**GENOA CHARTER TOWNSHIP BOARD**  
**Regular Meeting**  
**June 1, 2015**  
**6:30 p.m.**

**RE:** **PROVIDENCE MEDICAL CENTER**  
 PUD Amendment, Environmental Impact Assessment & Site Plan

<b>Attention:</b>	Kelly Van Marter, AICP Assistant Township Manager and Community Development Director
<b>Subject:</b>	Livingston Ambulatory – PUD Plan Review #2
<b>Location:</b>	East side of Latson Road, between Grand River Avenue and I-96
<b>Zoning:</b>	NR-PUD Non-Residential Planned Unit Development District

SHEET NUMBER:  
**C1.0**  
 PUD SUBMITTAL

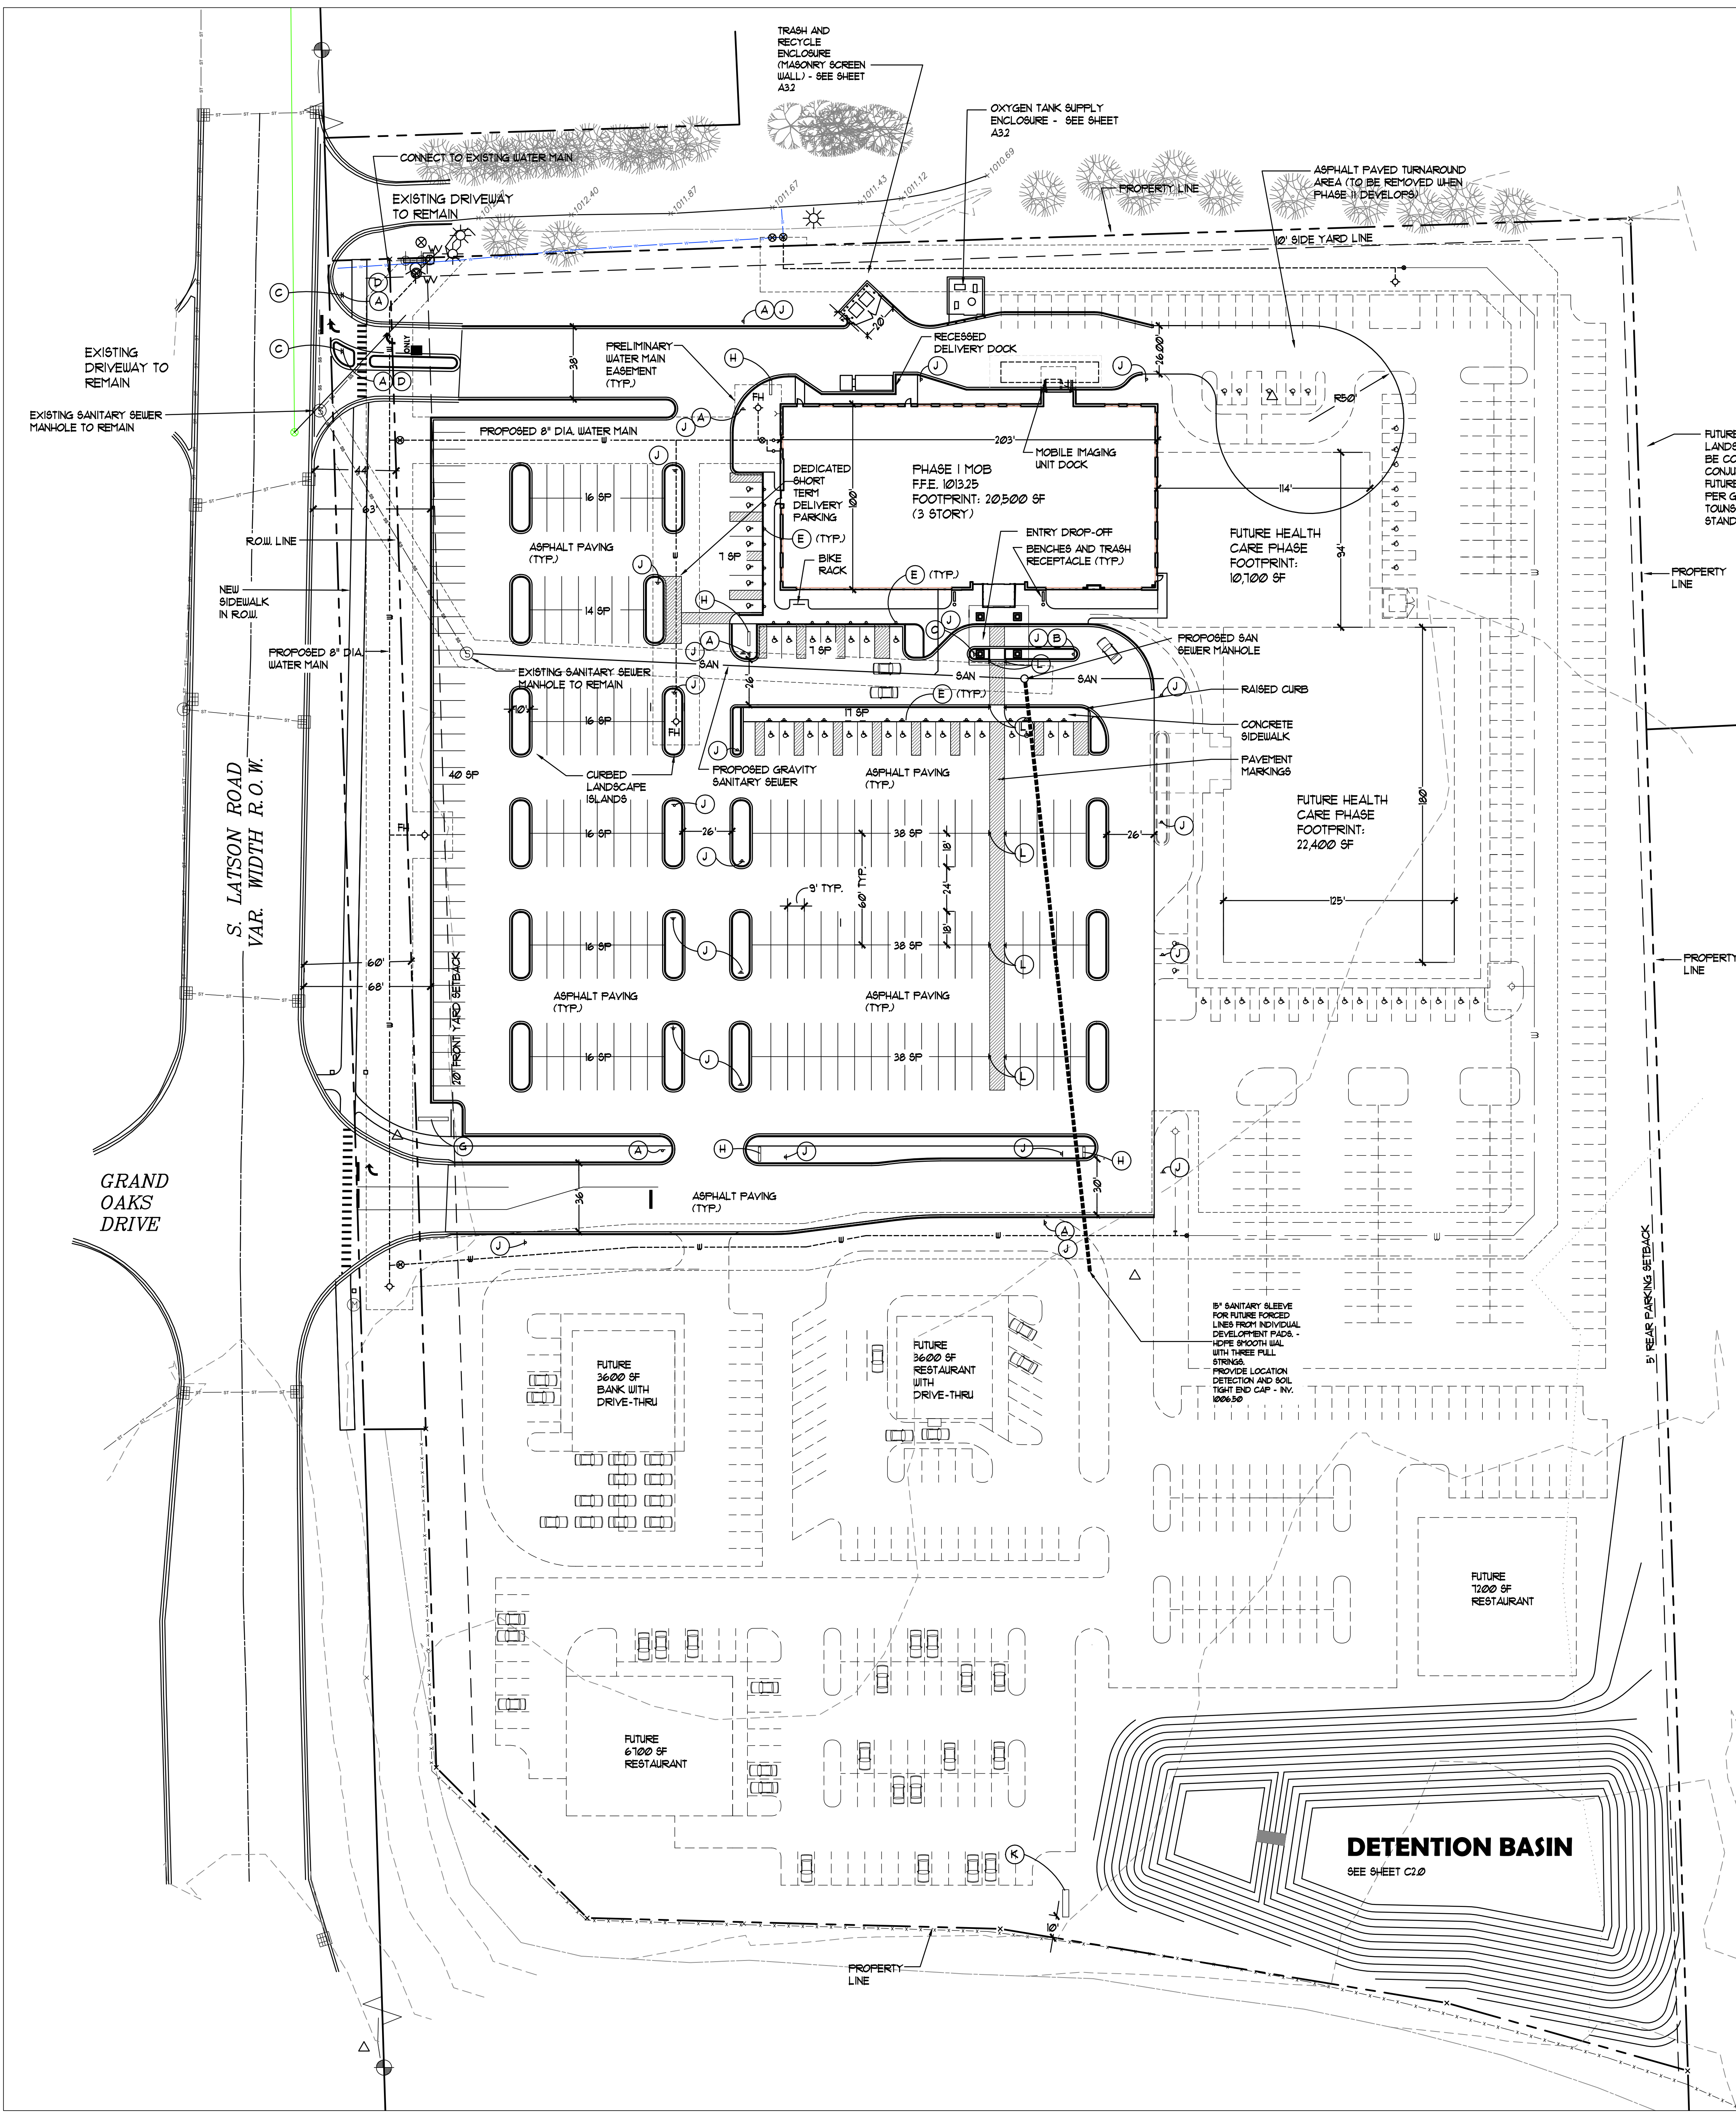
The highway sign meets the provisions of the PUD Agreement, although it appears to be mislabeled as a directional sign on Sheet C1.0. Additionally, the main wall sign and monument sign comply with the standards of Table 16.1, while the Planning Commission may allow the 2<sup>nd</sup> wall sign per Footnote (2).
